ADDENDUM NUMBER: TWO (02)

ADDENDUM DATE: March 21, 2016

PROJECT: New Modular Police Building and Employee Housing
Black Lake, Saskatchewan

This Addendum forms part of the Contract Documents and amends the original Drawings and Specifications dated 2015-12-04, previous Addenda if applicable and as noted below. This Addendum consists of 9 pages.

M1.3-R01

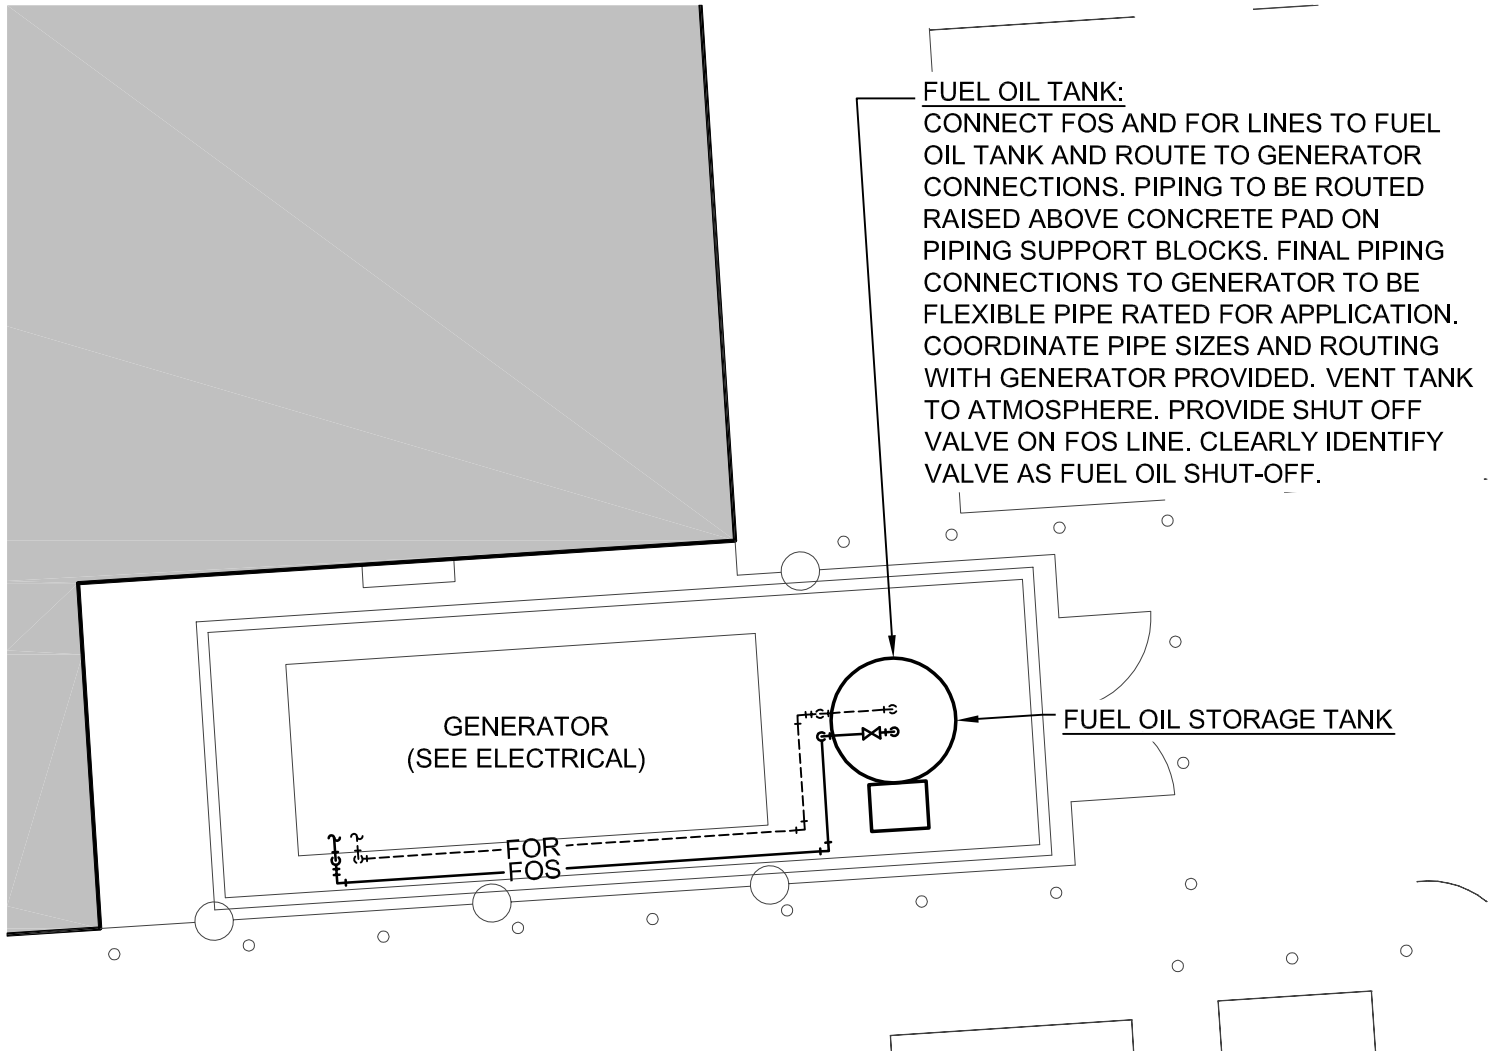
- .1 Refer to Mechanical drawing M1.3-R01 attached for fuel oil piping.
